AGENDA ITEM #12
 September 14, 2021
Public Hearing

Amendments to the Comprehensive Water Supply and Sewerage Systems Plan: Water and Sewer Category Change Requests

County Executive's May 2021 Amendment Transmittal to the County Council

WSSCR 20-TRV-14A: Transquest LLC

WSSCR 20-TRV-14A (Transquest LLC) & 20-TRV-15A (Travilah Oak LLC)
Proposed Low-Pressure Sewer Main Extensions: Comprehensive Water & Sewer Plan Map

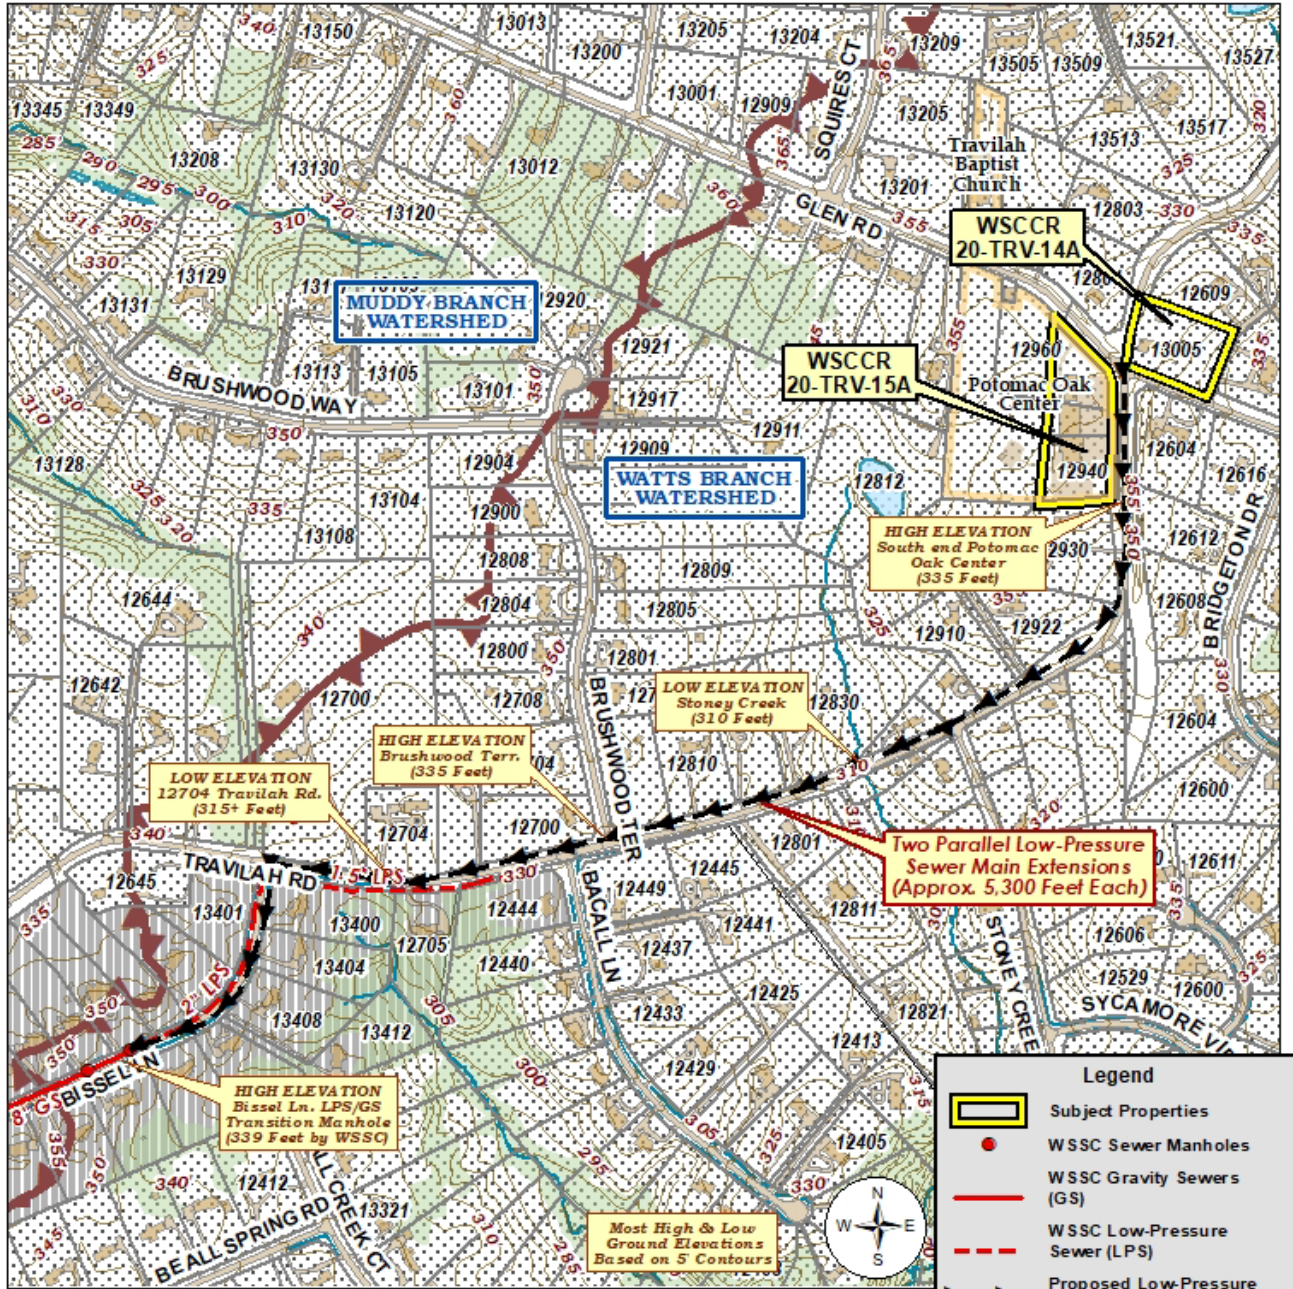
Basin: 16 – Watts Branch. A gravity sewer service to this property does not appear feasible due to the difference in elevations. A dedicated grinder system would be an alternative to gravity sewer but also brings issues. A 5,300-foot-long non-CIP-grinder system extension along Travilah Road would be required to serve the property. This extension would connect to an existing 8-inch diameter gravity sewer in Bissell Lane (Contract No. 89-8406A). The applicant suggested that this property could be served by a gravity sewer line to the Potomac Oak Center. [*] This would not follow WSSC Water's Development Services Code (DSC) or the Pipeline Design Manual (PDM) for the following reasons:

[The applicant's sewer service proposal for this request and for WSSCR 20-TRV-15A, involves a single low-pressure sewer extension with a private pumping facility on the Potomac Oak Center site that would serve both properties. Sewage from this site would flow under the intersection to the single pumping facility.]*

- 1) A private sewer extension within a public road dedication is not allowed. A public gravity sewer from the Old White House site to the Potomac Oak Center would not be allowed. A public sewer system cannot discharge into a private sewer system.

- 2) The Potomac Oak Center and the Old White House would be two non-residential customers served by the low-pressure sewer. Non-residential customers may not share a low-pressure sewer. (DSC page 88 and PDM Appendix C-7)

- 3) Detention time in the pressure sewer prior to discharge to the gravity system would be greater than 2 hours. Detention times would contribute to the generation and release of hydrogen sulfide and odors near the residential dwellings along Bissel Lane downstream of the transition manhole and at air valves along Travilah Rd. (PDM Appendix C-7, PDM S-28.1 & PDM S-26.1).

- 4) The proposed LPSS would pump downhill. Uphill pumping is preferred in a pressure sewer system where the point of discharge to gravity system is at a higher elevation than the rest of the system, to maintain positive pressure throughout the system. (PDM S-25.3) Vacuum pressure can occur at high points elevated above the transition manhole, when pumps shut down. Air vacuum valves would be needed. (PDM S-26.2) Air release and air and vacuum valves require frequent maintenance for them to function as intended. (PDM S-26.1)

- 5) The pressure sewer profile would have high and low points. Continuously rising profiles are preferable. Sewer air vacuum and air release valves will be required at all high points in the system. (PDM S-25.3) *[See page 24.]*

- 6) Through an internal hydraulic analysis, it was determined the minimum velocity of 3.0 fps could not be obtained.

Executive staff find that this request for category S-3 is inconsistent with both Water and Sewer Plan service policies and with master plan recommendations. WSSC's analysis presents problems with the proposed low-pressure sewer extension. This request is recommended for deferral of W-6 for a multiuse water system, pending an evaluation for a multiuse onsite sewerage system. The request is also recommended for denial of S-3 for public sewer service; maintain the existing S-6.
